SERVICE LETTER

No. 794

Piper Aircraft Corporation

Subject: Wing Tip Tank Drain Hose Replacement

CROSS-SECTION OF WING AND TIP TANK (LEFT WING SHOWN - RIGHT OPPOSITE)

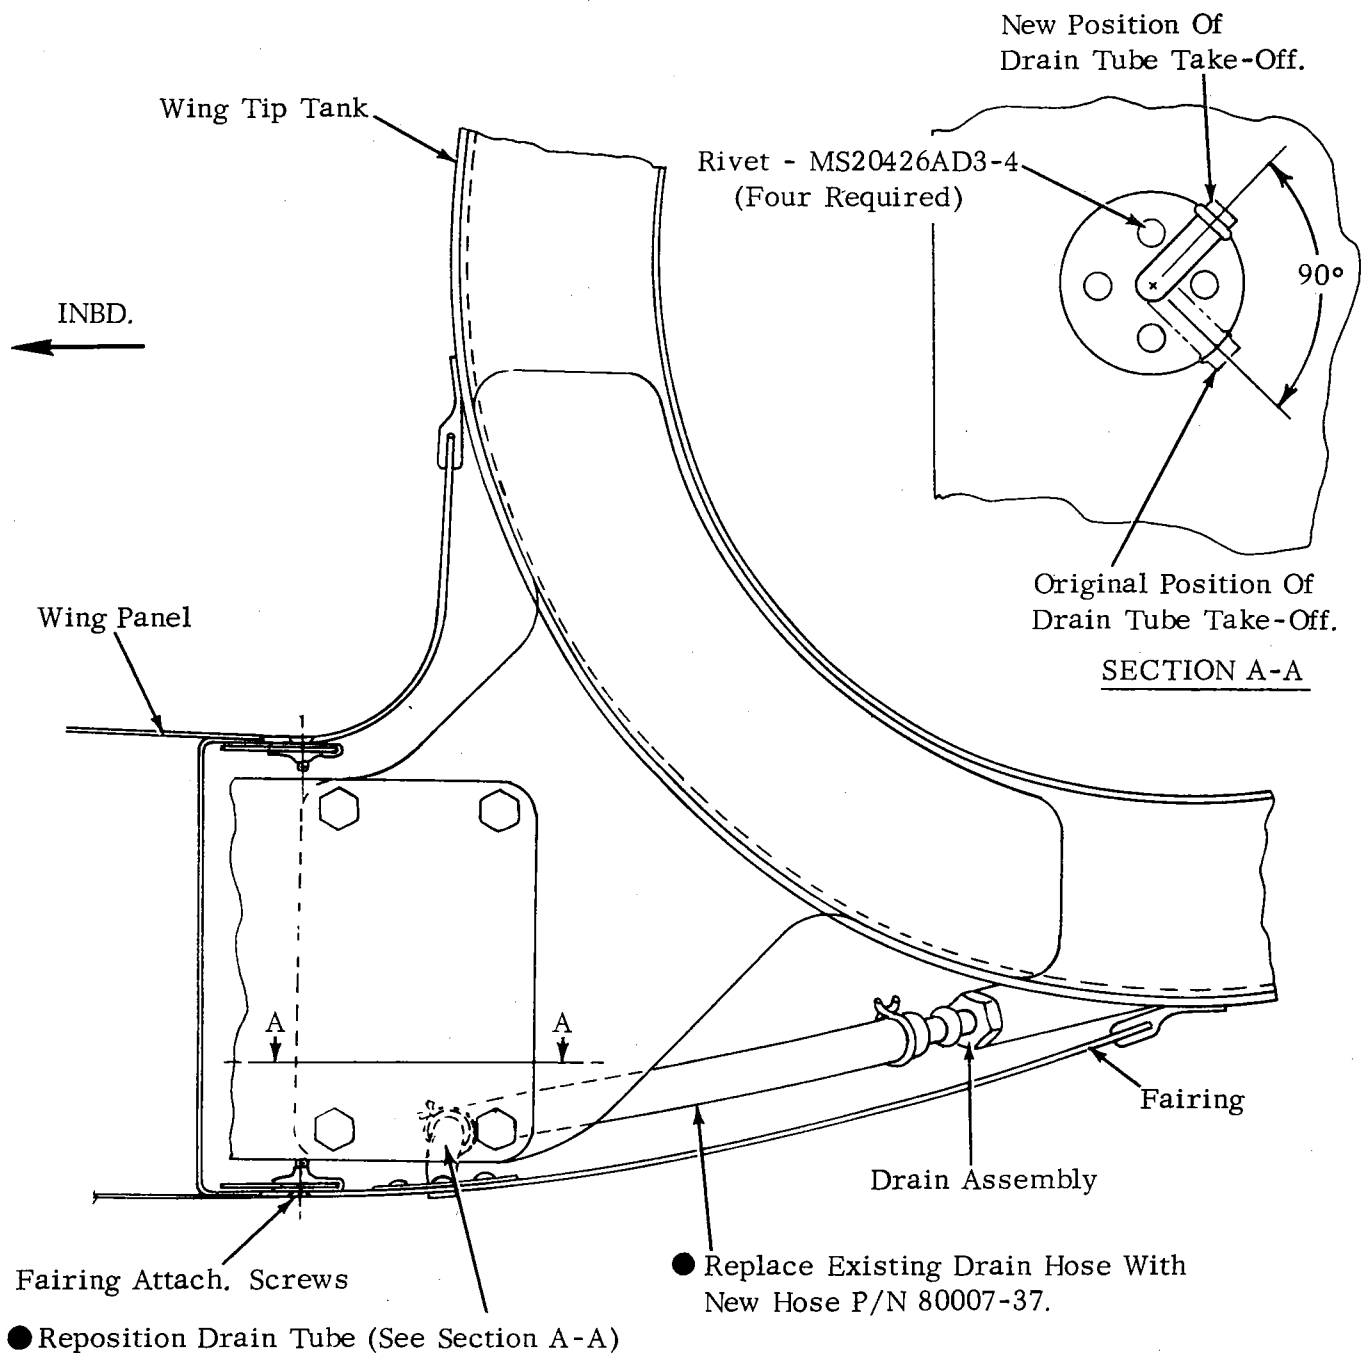
Purpose: A recent product condition report received from the field described a situation in which the wing tip fuel tank drain valve could not be actuated due to an improper drain hose installed between the fuel strainer drain valve and the drain outlet. Inspection revealed that the drain hose material deteriorated and prevented function of the drain.

This service release provides material and instructions to replace the existing drain hose with new hose (Piper part number 80007-37), constructed of material to improve hose service life (attached sketch/instruction sheet locates the subject hose).

1. Remove bottom screws securing forward wing tip tank fairings to left and right wing panels.
 - a. Remove existing drain hose. Retain clamps and discard hose.
 - b. Carefully remove rivets attaching the metal drain tube to the fairing. Reposition the drain tube take-off, 90° from the original position, as shown on Section A-A. Attach drain tube to fairing using four MS20426AD3-4 rivets.
 - c. Install new drain hose P/N 80007-37 using existing clamps.
2. Reinstall fairing attachment screws.
3. Make proper logbook entry of Service Letter compliance.
